## SUNDRY NOTICES AND REPORTS ON WELLS MAR 23 2010

Carson # 408 H

Energen Resources would like to make the following changes to the Carson #408. The changes will be as follows:

Attached is a revised C-102, directional drilling, operations plan and C-144.

## **Directional Plan**

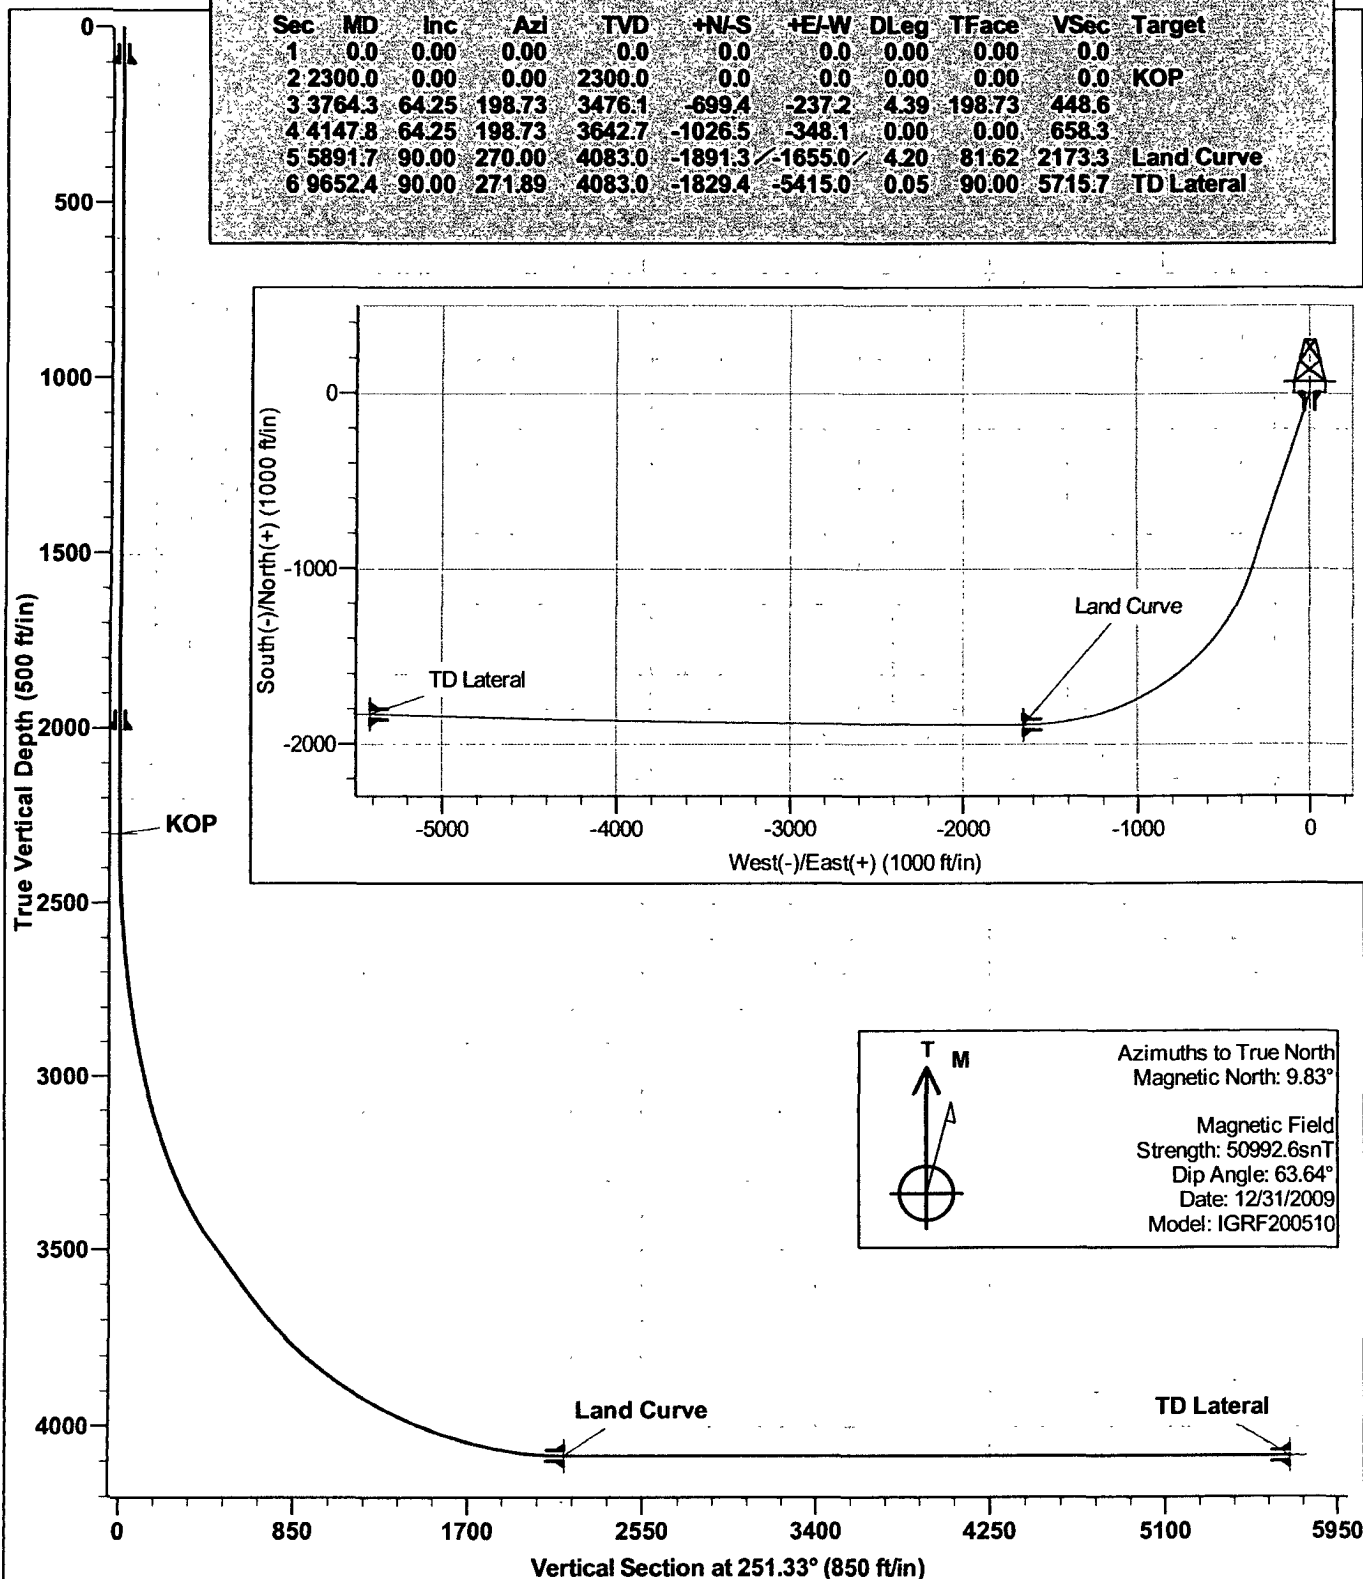
Land Curve:

$$Y \rightarrow \left[ (2642.48 + 2528.77) - (1680 + 1891.3) \right] \text{ Ft} \Rightarrow \underline{1600' \text{ FSL Sec. 34}}$$

$$X \rightarrow (1655 - 895) \text{ Ft} \Rightarrow \underline{760' \text{ FEL Sec 34}}$$
